Appendices Part 5

From: ARCF_SEIS <ARCF_SEIS@usace.army.mil>
Sent: Thursday, February 22, 2024 12:38 PM
To: Sutton, Drew
Cc: publiccommentARCF16@water.ca.gov; ARCF_SEIS
Subject: [EXT] FW: [Non-DoD Source] Comments Regarding American River Common Features (ARCF) 2016 Draft Supplemental Environmental Impact Statement/Subsequent Environmental Impact Report (SEIS/SEIR) – December 2023 Report and Appendices

My comments focus on the lower American River components of the draft SEIS/SEIR, particularly Contracts 3B, and 4A and 4B.

Figure 3: Map of Index Point Locations Considered in Geotechnical Report. Only 2 index points are used for the entire Lower American River

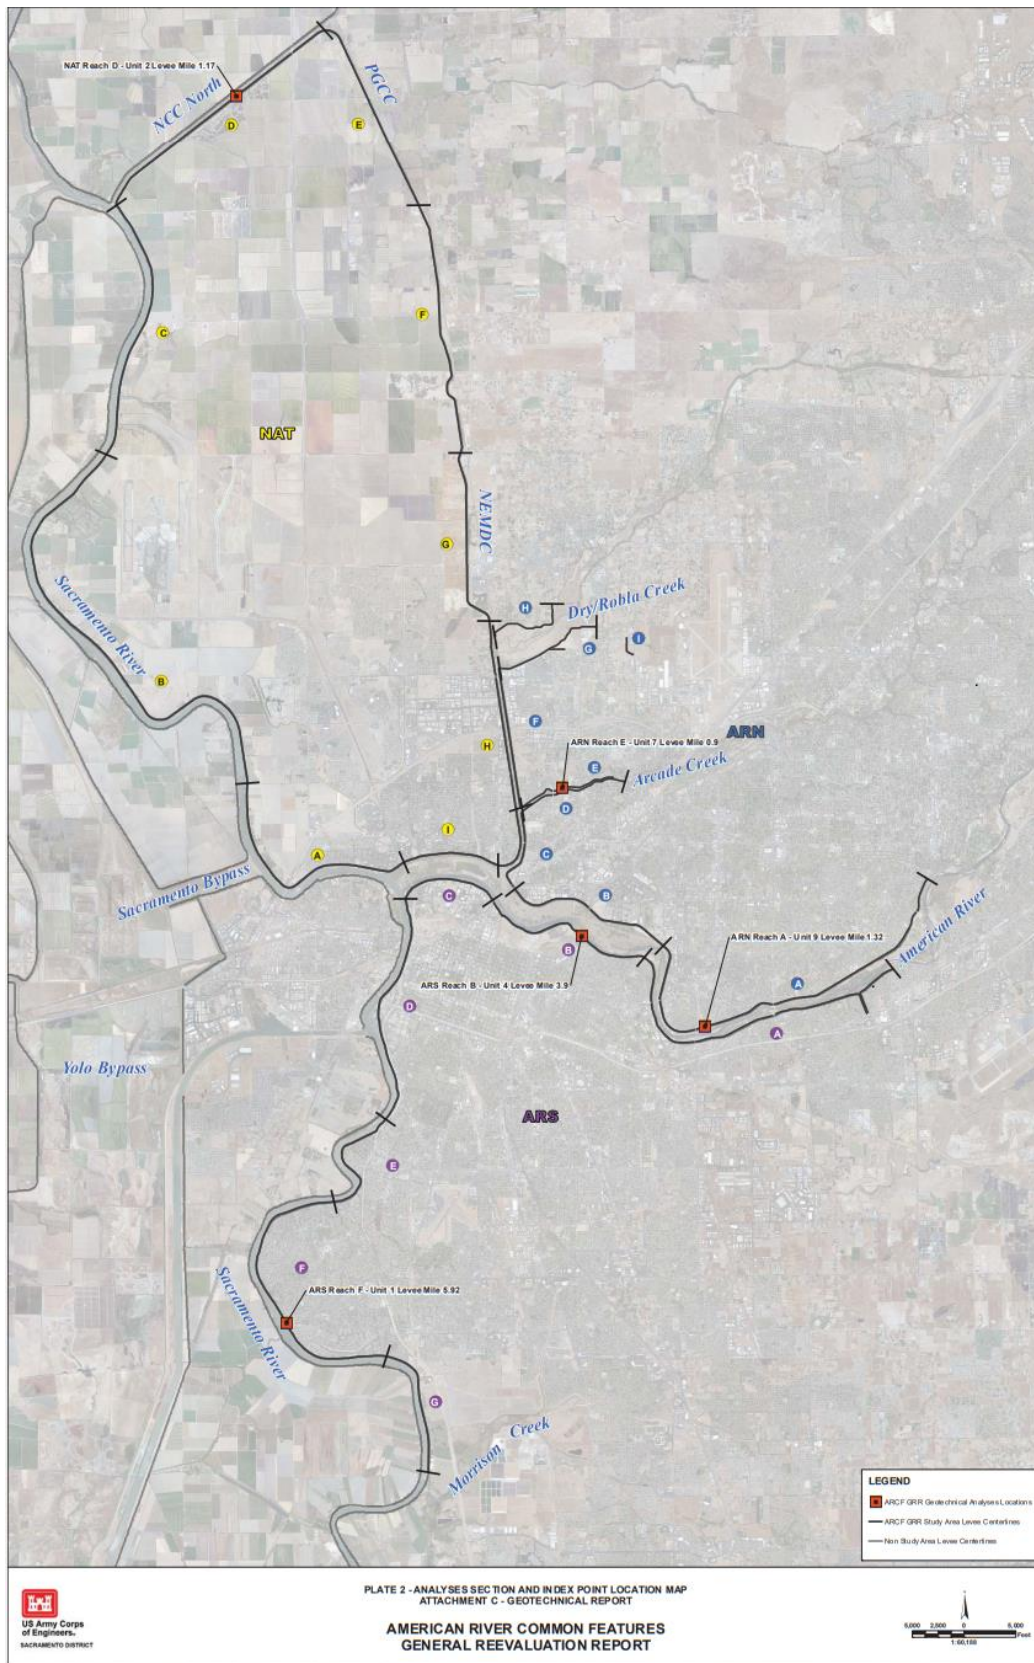
The use of a boring near Howe Avenue Bridge to justify work two miles upstream is especially egregious because the *Erosion Protection Report* indicates that the banks upstream of Howe Avenue consist of fundamentally different bed materials than the banks downstream of Howe Avenue. According to the *Erosion Protection Report*, the area between river mile 6.6-7.5 contains “broader areas of scour where the formation is likely more widely exposed in the channel bed or lies concealed beneath a thin cover of active channel only a few feet thick.”⁴³ This unit “contains no bank resistance to lateral erosion and will not contribute to levee stability.”⁴⁴ This is, in other words, an area with highly erodible bed materials. However, the area upstream of Howe Avenue, especially near the entrance of SARA Park (left bank river mile 10.0-10.3) where the Corps proposes to install a launchable rock trench and launchable rock toe, contains significant amounts of erosion-resistant clay hardpan, which the technical documents refer to as the “Pleistocene Fair Oaks Formation.”⁴⁵ The only modeling results USACE provides for the area containing Pleistocene Fair Oaks Formation, between river mile 7 and river mile 11, indicate that “for all the flows simulated the sheer stress in the reach with locally exposed hard material is below the critical stress for erosion of moderately resistant material (clay and cemented sand with silt). **Therefore, significant scour below this erosion resistant material/surface is not anticipated.**”⁴⁶

Figure 21. American River Velocity Contours.

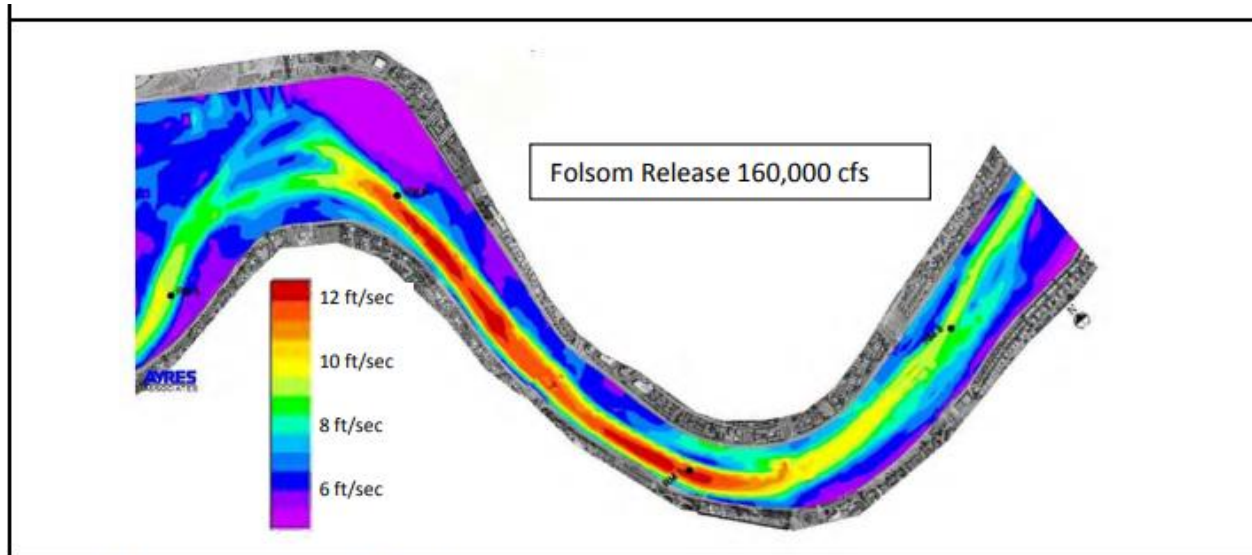
Yet in the appendices for the 2016 Final EIS-EIR, USACE only provided specific velocity data for RM 6 and RM 7.5.

Figure 2-8: Velocities in the Lower American River at a discharge of 160,000 cfs

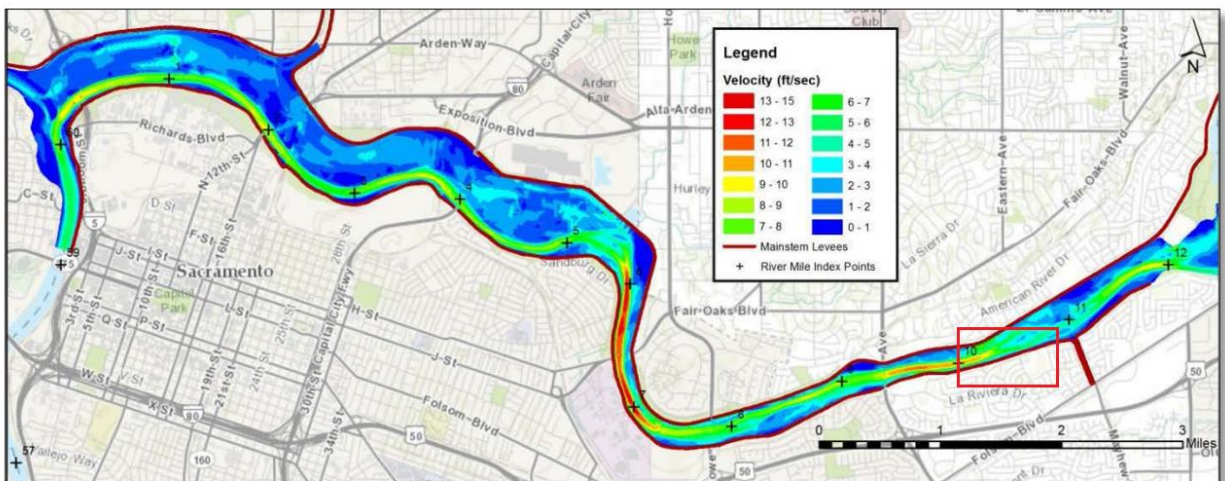
Such observations are consistent with the velocity contour maps in the *General Reevaluation Report*.⁶³ While these maps show that at 160,000 cfs velocities along the some of the LAR’s banks can reach a significant velocity of 12-13 ft/sec, between left bank river miles 10 and 11, which comprises most of Contract 3B South, estimated velocities along the banks during a 200 year, 160,000 cfs event only range from 0-1 ft/sec to 6-7 ft/sec. At these velocities

Figure 9

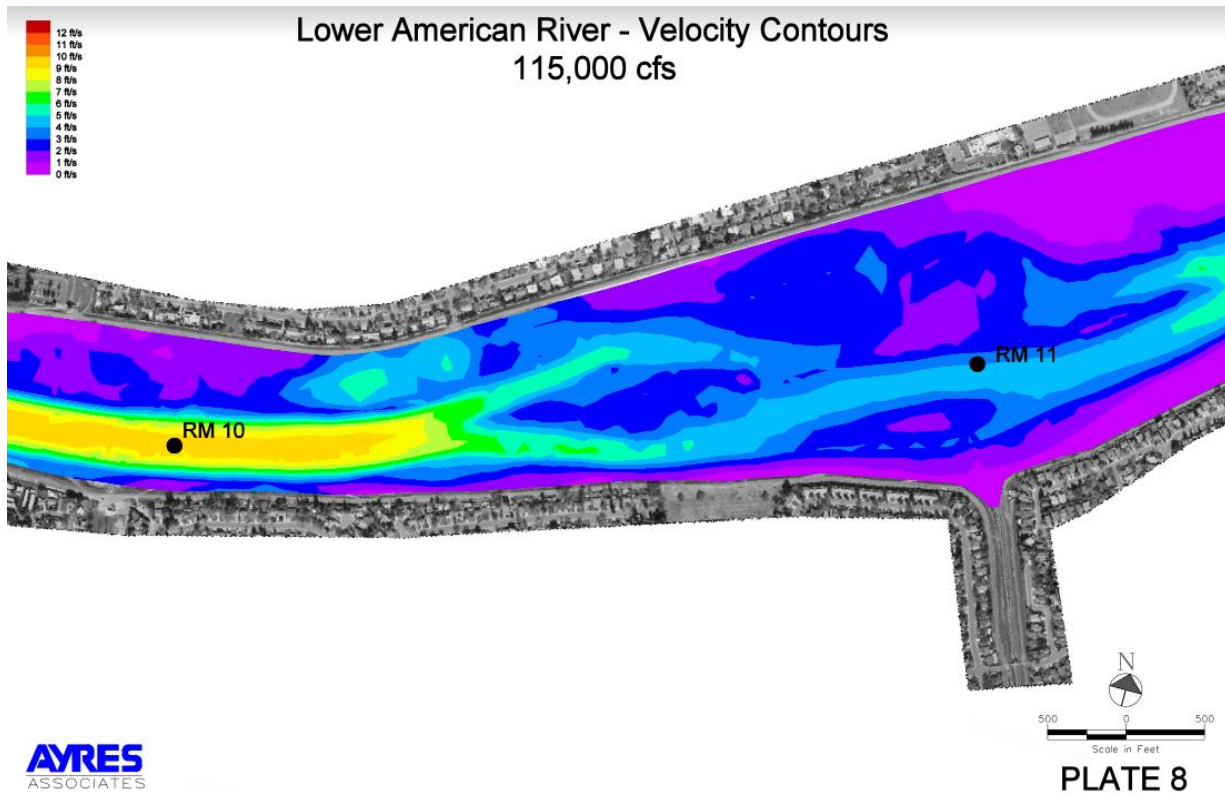
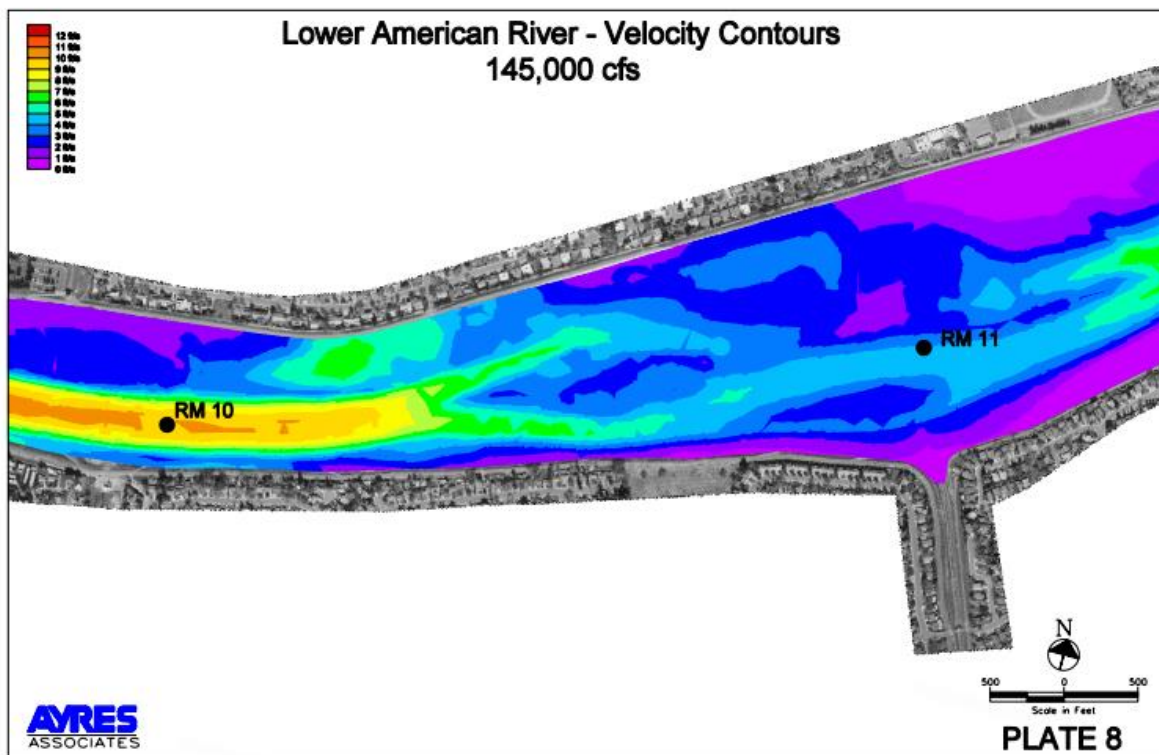
USACE’s velocity contour maps may show even lower velocities along the banks. The quality of the maps seems biased towards justifying the most extreme possible erosion measures, as the maps are too zoomed out to precisely ascertain river flow velocities along the banks, except for river mile 6.6-7.5, which happens to be part of the Lower American River where velocities are fastest along the banks. For this segment of the river, USACE provided high quality, zoomed in maps (Figure 4). None of the other sub-reaches of the Lower American River got such scrupulous treatment. For left bank river mile 10-11, where USACE proposes three launchable rock toes and a launchable rock trench, we can better perceive the river’s flow behavior by looking at the velocity contour maps from the *2017 Lower American River Streambank Erosion Monitoring Report*, which were derived from the same hydraulic modeling as the velocity contour maps provided in the 2016 *General Reevaluation Report* (GRR).⁶⁶ The more high quality maps from the 2017 report show that from 115,000 cfs to 145,000 cfs, there is little change in the velocity of flows along left bank river mile 10 to 11. In both cases, the water is almost stagnant, moving at 0-2 ft/sec for most of the river mile and rising to only about 4-6 ft/sec at around left bank river mile 10.⁶⁷

145,000 cfs does not quite get us to the 160,000 cfs mark, but it should be emphasized that there was very little change from 115,000 to 145,000 cfs, that some of USACE's experts noted low velocities near levees at 160,000 cfs between river miles 9.8 and 10.5, and that even the discernable part GRR's low resolution velocity contour maps show that at worst river velocities reach 6-7 ft/sec around left bank river mile 10.

Figure 13: Resident picture of left bank river mile 10.4-10.5 during the 2017 high water event (80,000 cfs). The water was so stagnant his dog could wade in it.

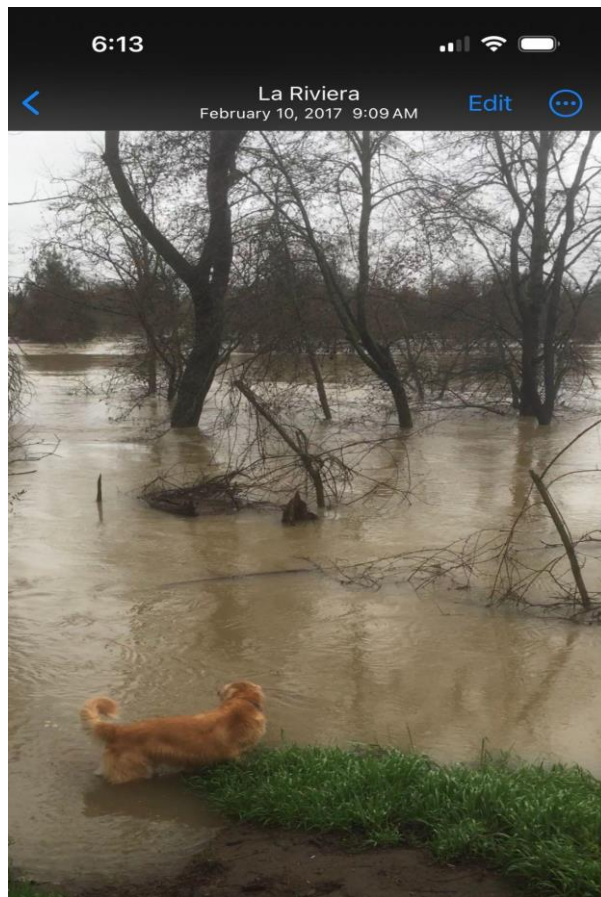
USACE still cites as the basis for its Contract 3B proposal the 2-D hydraulic modeling from the 2004 Ayres Report, *Lower American River, Erosion Susceptibility Analysis for Infrequent Flood Events*.⁸³ This outdated 2-D hydraulic model almost certainly overestimates velocities along banks with large trees. As Khosronejad's team explained:

Figure 1. Bank Protection and Launchable Rock Trench Typical Design.

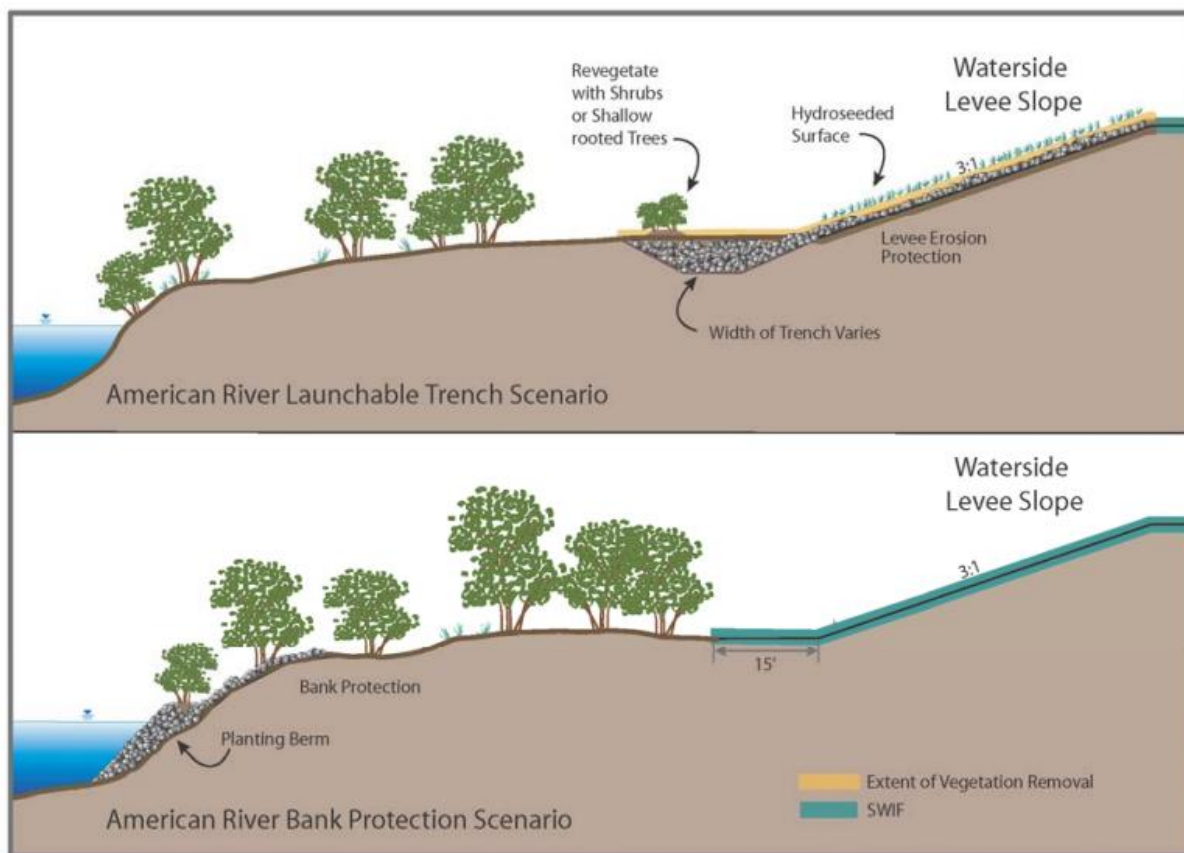
figure 1 of the Final EIS/EIR (figure 4-9 in the *General Reevaluation Report*) shows that tree removal would only occur on the levee itself and at the base of the levee.¹⁰⁰ It indicates that USACE would spare most trees on the riparian bench and on the natural levee slope. For “American River Bank Protection Scenario,” no part of the bank is highlighted for vegetation removal or tree clearing.¹⁰¹ From these diagrams, an apprehensive citizen could reasonably conclude USACE would remove few trees, if any at all, while installing either launchable rock trenches or bank protection.

Figure 3.5.2-3. American River Erosion Contract 3B Project Footprint

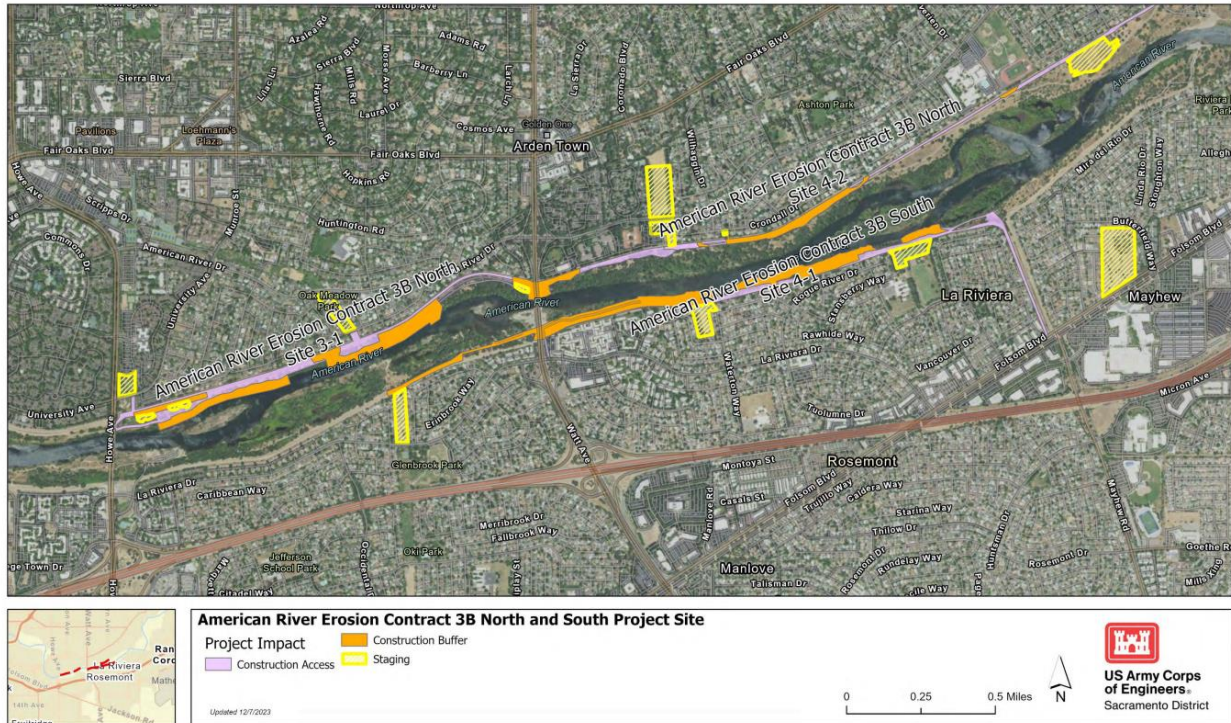
What is an apprehensive citizen supposed to make of these differences? Why is the non-project area between Watt and Glenbrook River Access labeled a construction buffer zone while the non-project area between the Mayhew Drain and Larchmont Park is labeled a construction access zone? There is no effort on USACE’s part to clearly communicate what this figure means and what implications construction access and construction buffer zones will have for residents near the Contract 3B South footprint.

Figure 25

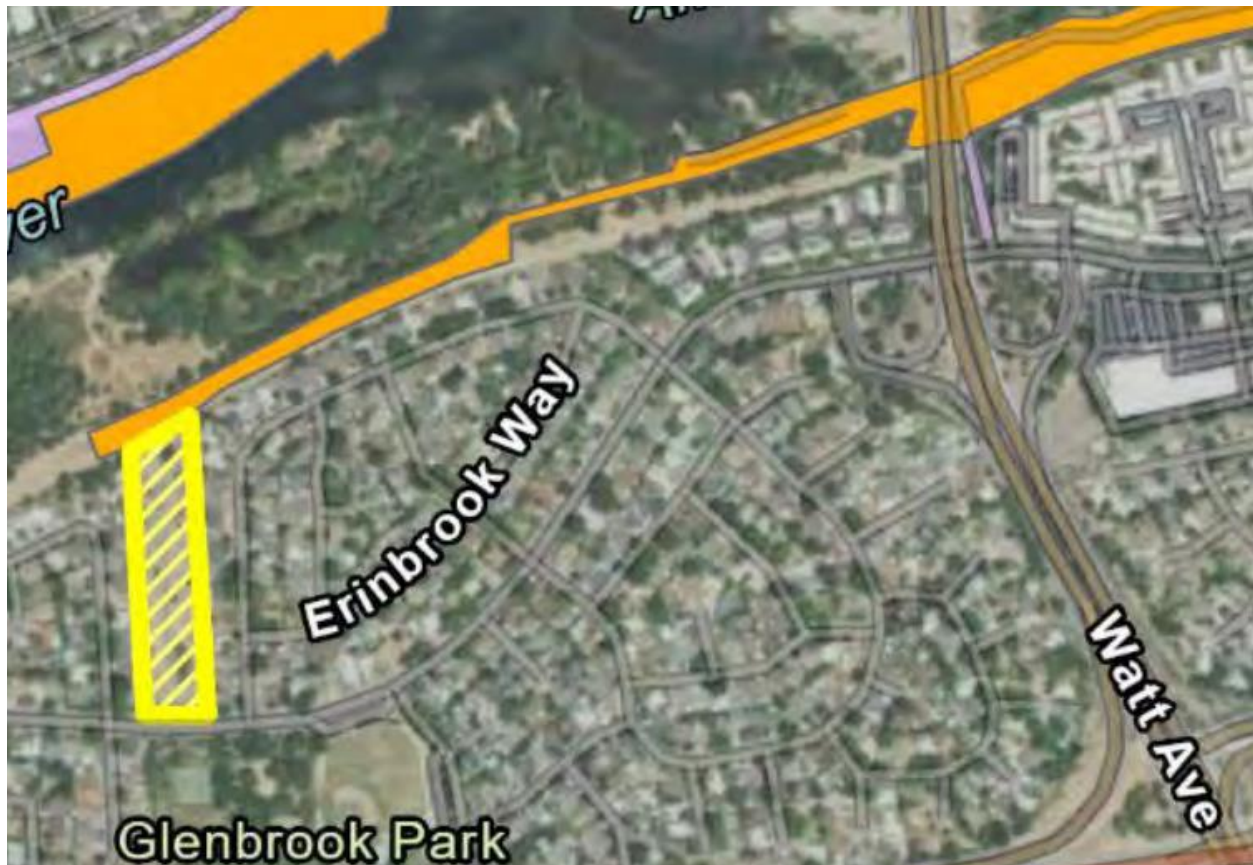
As with the area between Larchmont Park and Mayhew Canal, the area between Watt Bridge and Glenbrook River Access is not slated for erosion protection measures, but trucks will need to use this area to transport materials to and from the project area. Unlike the area between Larchmont Park and Mayhew Canal, the area between Watt and Glenbrook River Access is colored orange, indicating it is a “construction buffer” zone.

Figure 3.5.2-9. American River Erosion Contract 3B South Site 4-1 Details

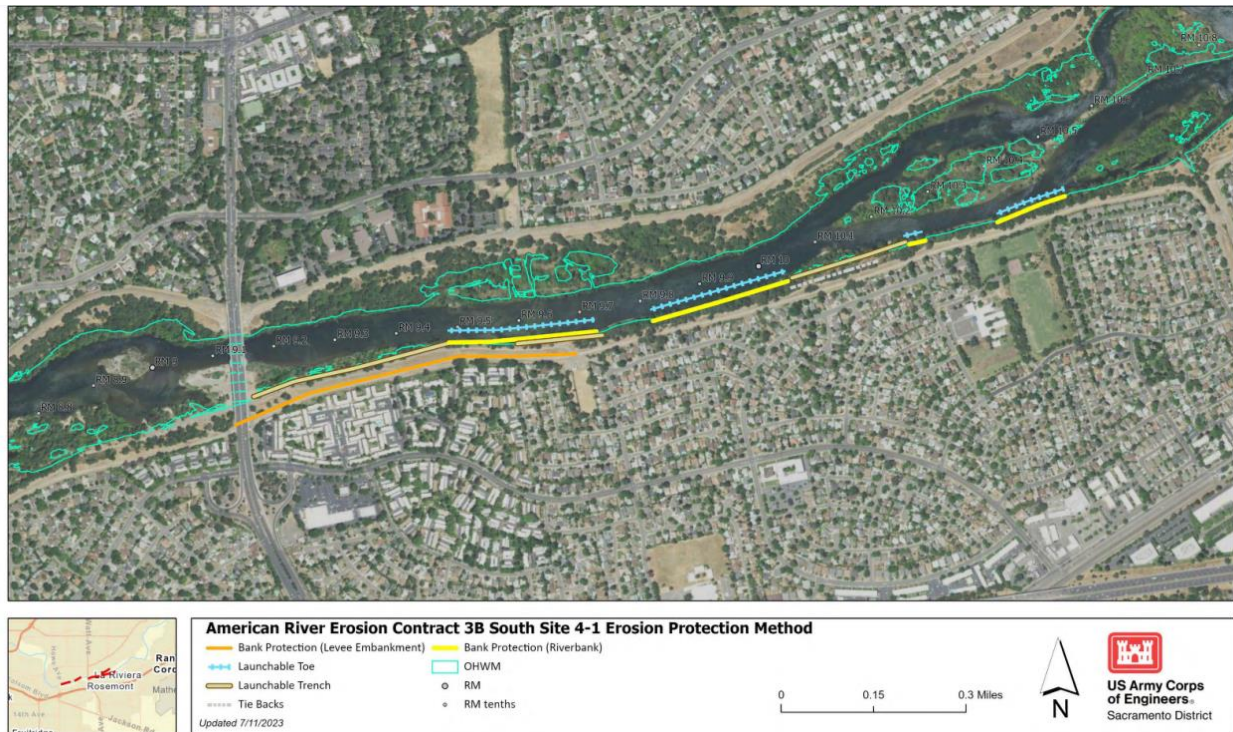
By contrast, the visual projections of USACE’s proposed work for the 2023 Draft SEIS/SEIR are vague and overly generalized.¹¹⁹ Instead of site-by-site diagrams for Contract 3B South, USACE provides a zoomed-out map with lines indicating where launchable rock toes, trenches, and bank protection will be implemented. It is impossible from this visual (figure 27

below) to ascertain any meaningful environmental or recreational impacts. Instead of site-by-site descriptions of soil filled revetments, USACE simply provides figures which illustrate the general concept of launchable rock toes, trenches, and planting benches (see figure 16).¹²⁰ The pictures of American River Contract 1 and 2 already demonstrate that we can expect little resemblance between USACE's conceptual diagrams and the final work.

14. The document states that there are locations at Site 4-1 where there is a launchable toe at the riverbank toe (referred to as bank toe in Figure 3.5.2-9), unlike the typical launchable toe at American
